BEFORE 1 THE PUBLIC SERVICE COMMISSION OF 2 **SOUTH CAROLINA** 3 4 **DOCKET NOS. 2021-88-E** 5 6 South Carolina Energy Freedom Act Docket No. 2021-88-E (H.3659) Proceeding to Establish Dominion Energy South Carolina, Inc.'s Standard Offer Avoided Cost Methodologies, Form Contract Power Purchase Agreements, Commitment to Sell Forms, and Any Other Terms or Conditions Necessary (Includes Small Power Producers as Defined in 16 United States Code 796, as Amended) – S.C. Code Ann. Section 58-41-20(A)) 7 8 9 10 11 12 DIRECT TESTIMONY OF ED BURGESS 13 14 15 ON BEHALF OF 16 17 18 THE CAROLINAS CLEAN ENERGY BUSINESS ASSOCIATION 19 20 21 22 23 24 25 July 27, 2021 26 27

1 <u>DESC Avoided Cost Testimony of Ed Burgess</u>

5 Figure 1. Comparison of modeled incremental Operating Reserves assumed in DESC's VIC

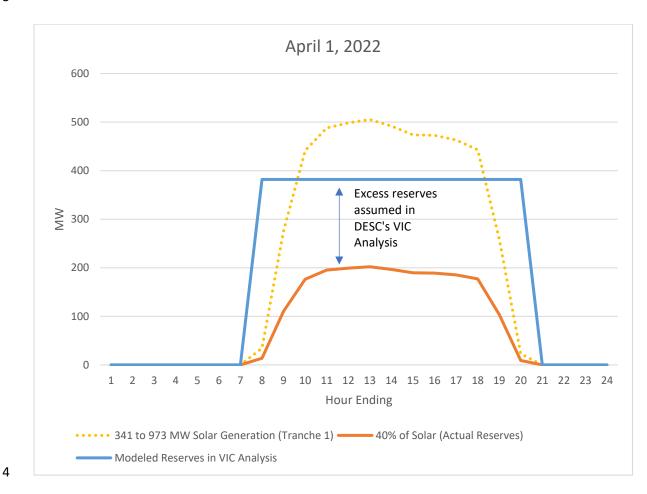
A. Yes. The chart below provides an illustrative example of how DESC's VIC analysis includes extremely inflated estimates of incremental operating reserve requirements for solar. On this chart, the yellow dotted line is a plot of estimated hourly solar generation from Tranche 1 facilities for a day in April 2022. The data used to generate this plot were taken directly from DESC's VIC workpapers and reflects the exact amount of Tranche 1 solar production included in Guidehouse's model for this day. Meanwhile, the orange line reflects the corresponding amount of operating reserves DESC's system operators would be likely to hold to accommodate Tranche 1 solar. As explained above, the standard practice of DESC's system operators is to hold "operating reserves in the amount of 40% of the hourly solar forecast or 40% of actual solar generation" in order to account for solar variability. The orange line in the chart represents 40% of the modeled solar generation. Finally, the blue line represents the incremental operating reserves assumed by Guidehouse to model integration costs. As noted in Exh. PBD-2 Table 9, the incremental operating reserves for Tranche 1 were assumed to be 382 MW for the month of April.³ What is readily apparent from this chart is the stark difference between the orange and blue lines, revealing how much higher the operating reserves are in the Guidehouse analysis when compared to what is more realistic based on DESC's actual operating practices. In fact, for this particular day, the excess in modeled operating reserves ranges from 89% higher to 4,041% higher than what is realistic based on DESC's actual operating practices.

- 1 While this represents an illustrative example for a single day, this pattern exists for every day in
- 2 DESC's analysis.
